## REMARKS

DRAWING SHEET, WITH RED ANNOTATIONS  
TO INDICATE REVISIONS,  
OF U.S. PATENT APPLICATION 09/560,109  
ATTORNEY DOCKET NO. M-5628 US

Figure 20 A

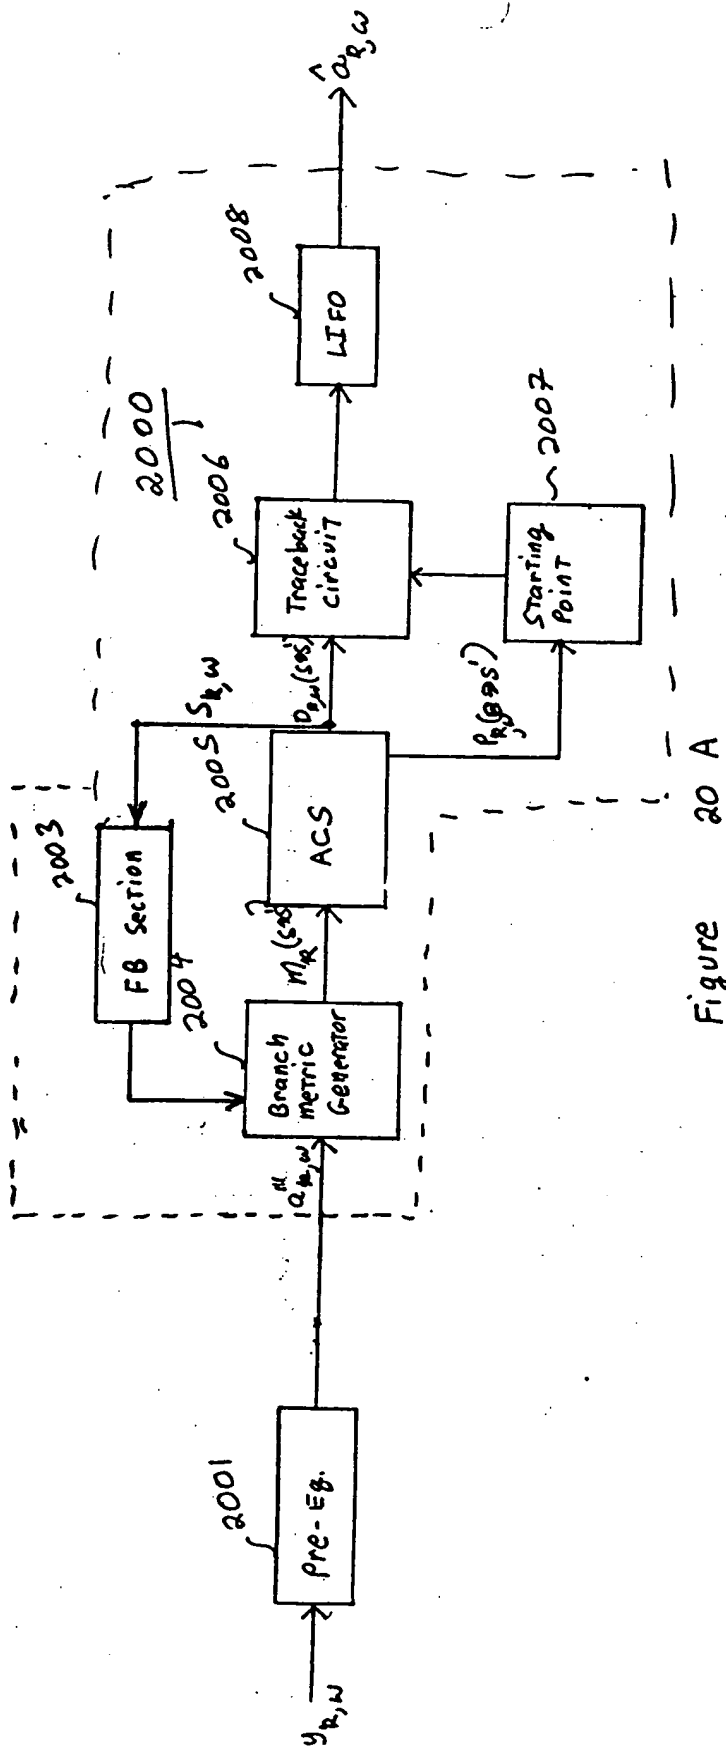
Applicants' Attorney has requested that the labels for blocks 1101, 1102, and 1105 in Fig. 11A, the labels for blocks 1501-1, 1501-2, 1501-3, 1501-4, and 1504 in Fig. 15, the label for block 1603-w in Fig. 16, the label for block 2003 in Fig. 20A, and the label for block 2100 in Fig. 20B be revised to conform with how the items corresponding to those blocks are described in the specification. Applicants' Attorney has also requested that the label "Starting Point" for block for 2007 in Fig. 20A be changed to "Starting Point Determiner" to conform with how blocks 1306, 1406-w, and 1605-w in respective Figs. 13, 14, and 16 are labeled "Starting Point Determiner".
